Project	IEEE 802.16 Broadband Wireless Access Working Group < http://ieee802.org/16 >	
Title	In-band Transparent Relay Frame Structure	
Date Submitted	2007-04-18	
Source(s)	<p>Kanchei (Ken) Loa, Yi-Hsueh Tsai, Yung-Ting Lee, Heng-Iang Hsu Shiann-Tsong Sheu, Frank C.D. Tsai, Youn-Tai Lee, Chih-Chiang Hsieh, Hua-Chiang Yin, Institute for Information Industry 8F., No. 218, Sec. 2, Dunhua S. Rd., Taipei City, Taiwan.</p> <p>Gang Shen, Kaibin Zhang Alcatel-Lucent, Research & Innovation 388#, Ningqiao Road, Shanghai, China. [add co-authors here]</p>	<p>Voice: +886-2-2739-9616 loa@iii.org.tw</p> <p>gang.a.shen@alcatel-sbell.com.cn</p>
Re:	IEEE 802.16j-07/013: "Call for Technical Comments Regarding IEEE Project 802.16j"	
Abstract	This contribution proposes in-band transparent relay frame structure	
Purpose	Text proposal for 802.16j Baseline Document	
Notice	This document has been prepared to assist IEEE 802.16. It is offered as a basis for discussion and is not binding on the contributing individual(s) or organization(s). The material in this document is subject to change in form and content after further study. The contributor(s) reserve(s) the right to add, amend or withdraw material con

Figure yyy Example of configuration for an in-band transparent relay frame structure

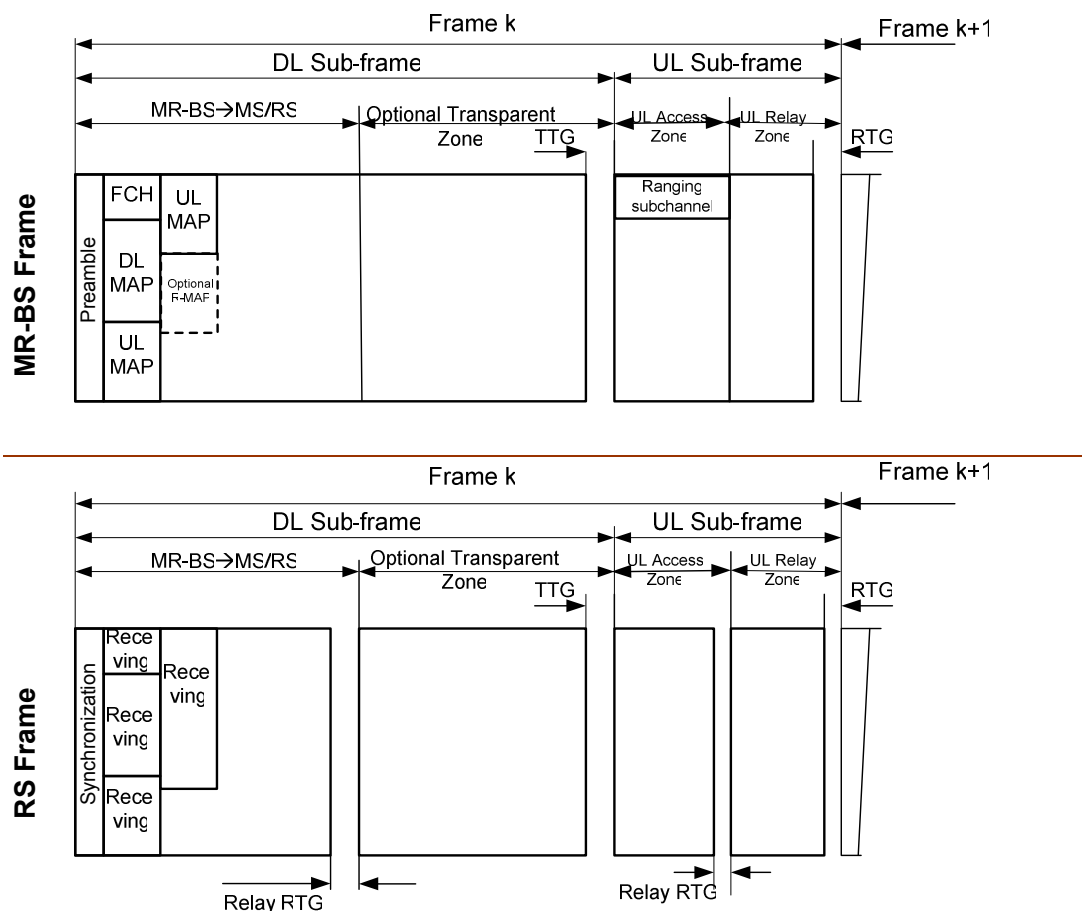
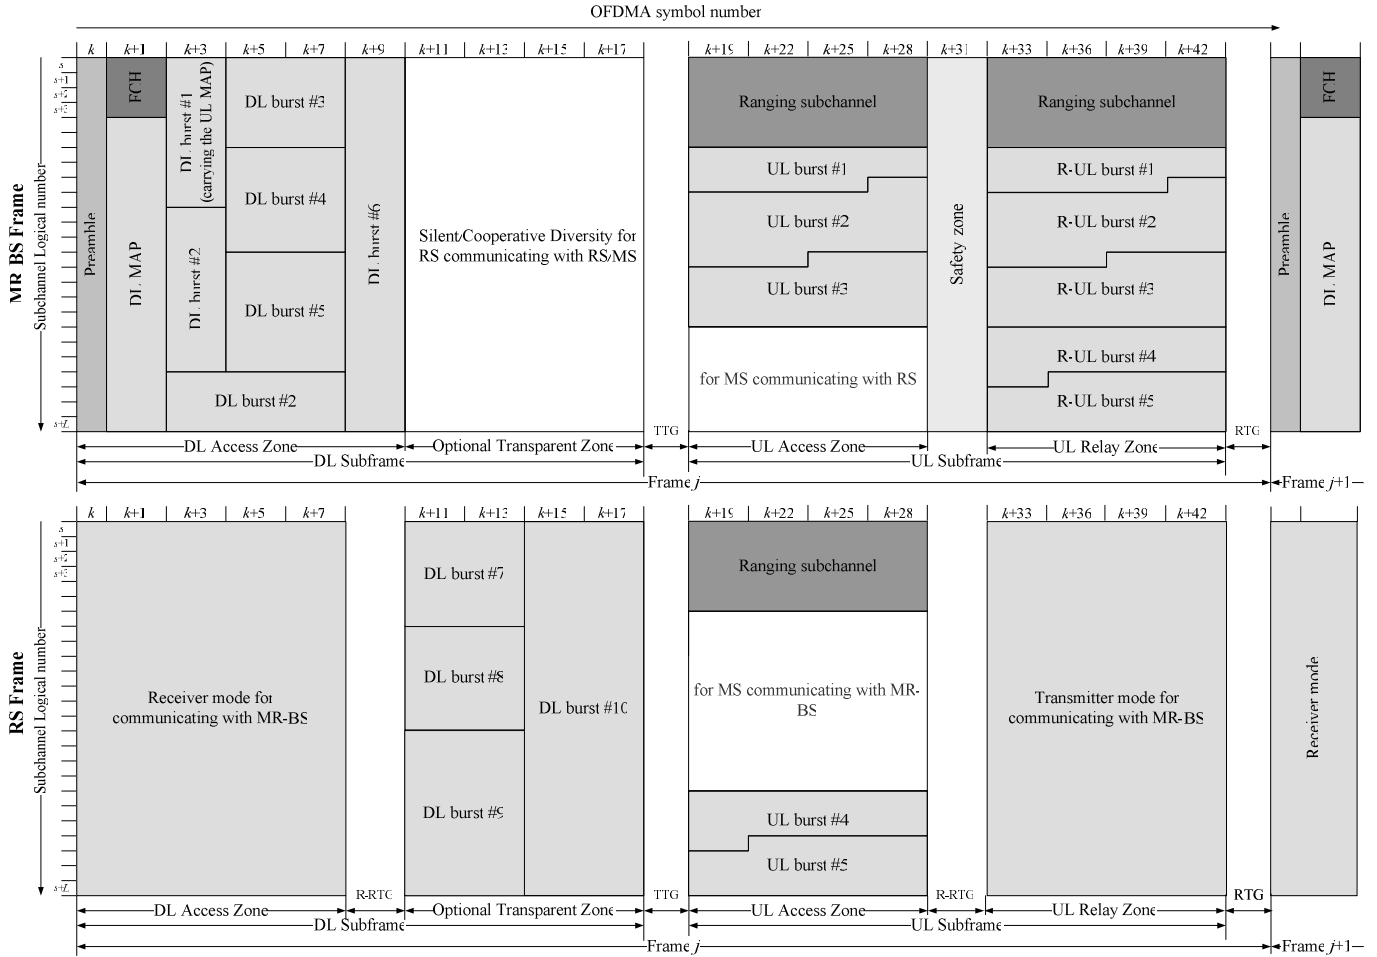
[Change the figure in section 8.4.4.7.1 “Frame structure for transparent mode” as indicated:]

[Replace Figure xxx with Figure yyy as follows:]
